RETREAT AT TIMBERRIDGE FILING NO. 3

COUNTY OF EL PASO, STATE OF COLORADO

CONSTRUCTION DRAWINGS

NOVEMBER 2022

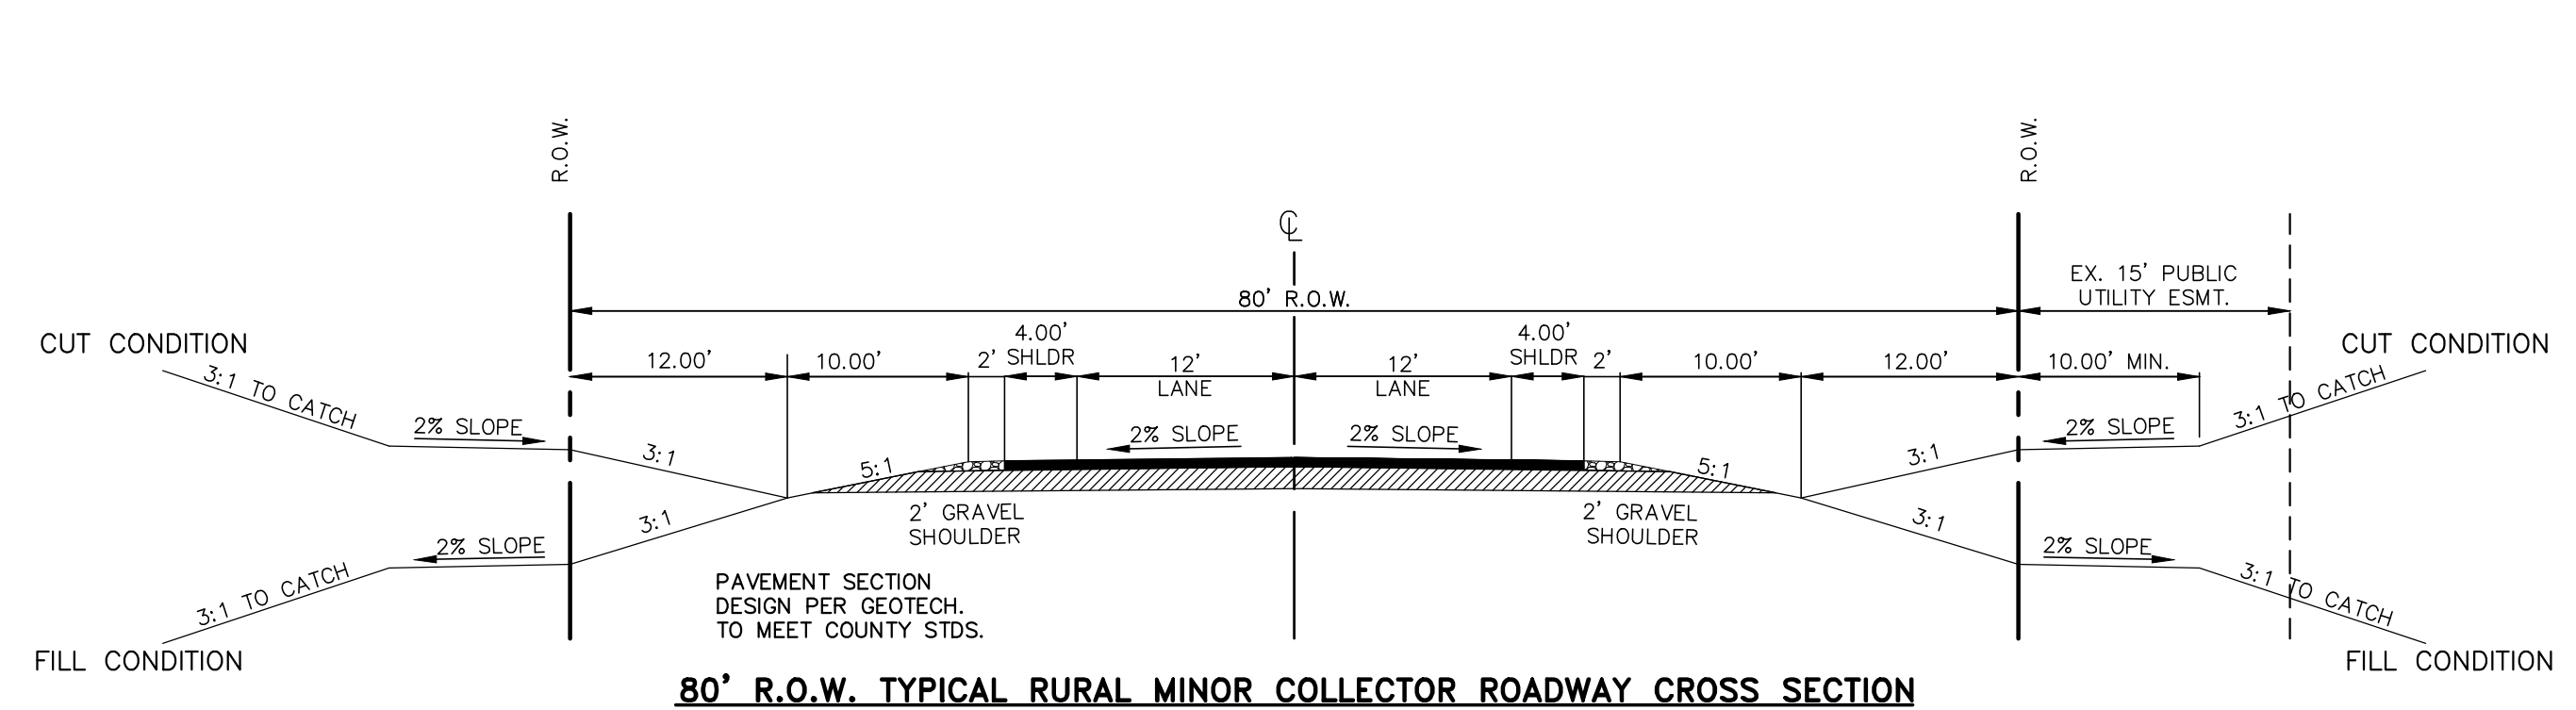
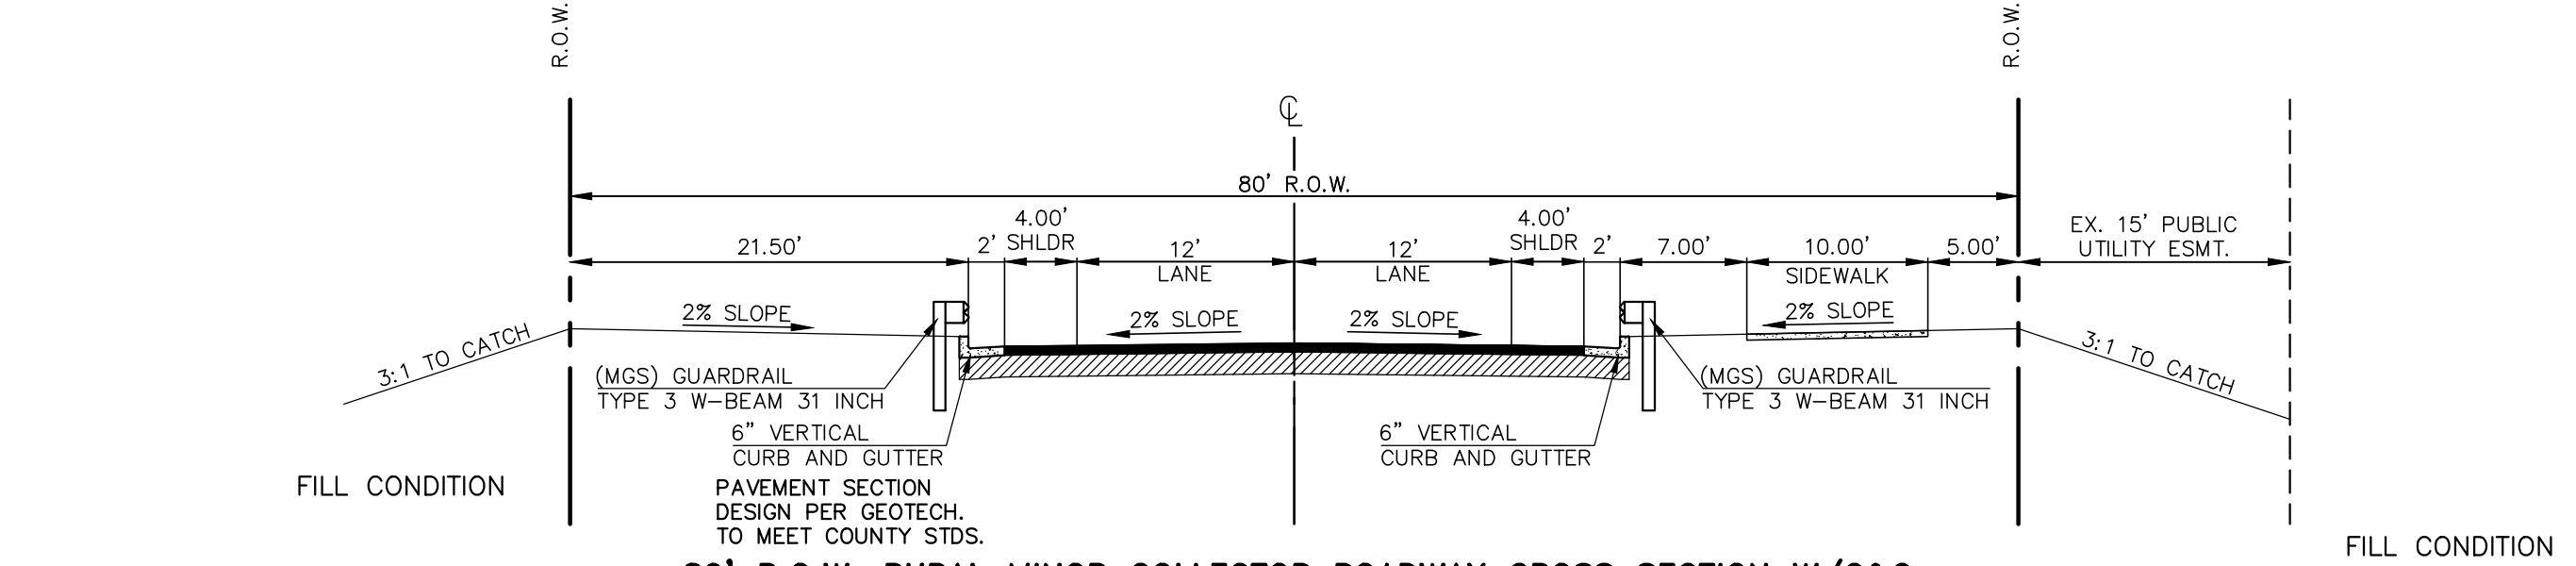
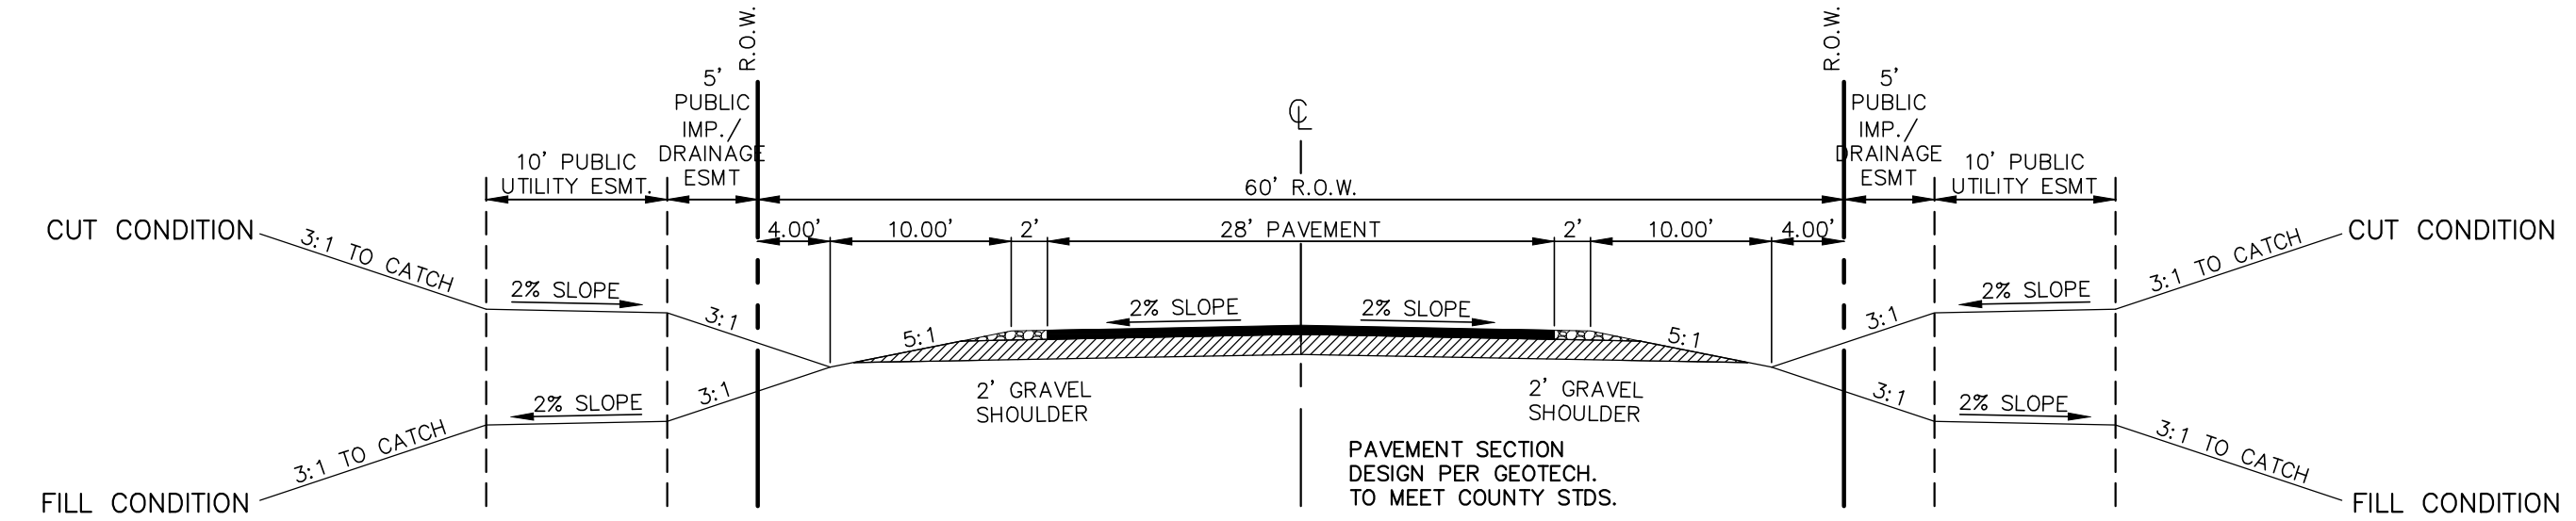
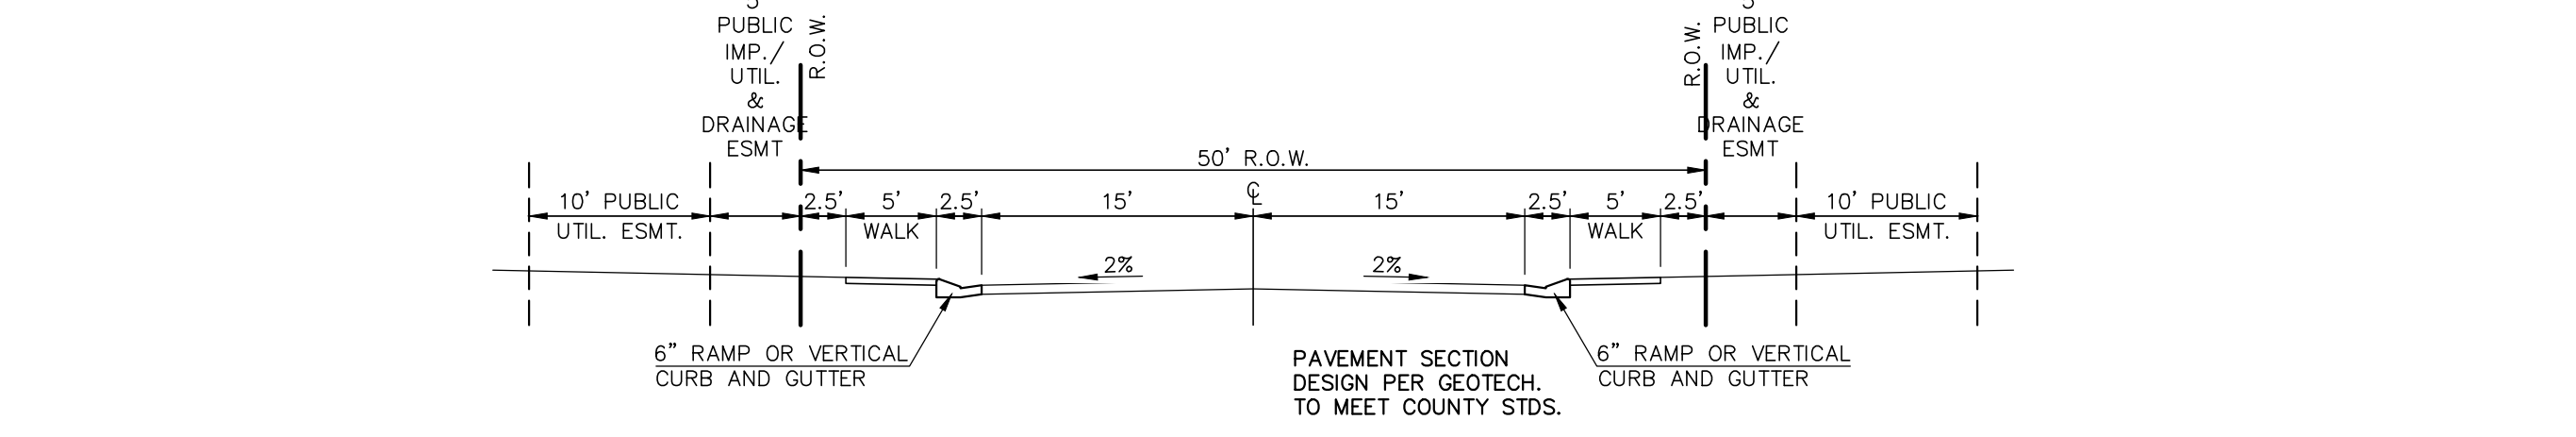
Provide a cross-section for the proposed trail.
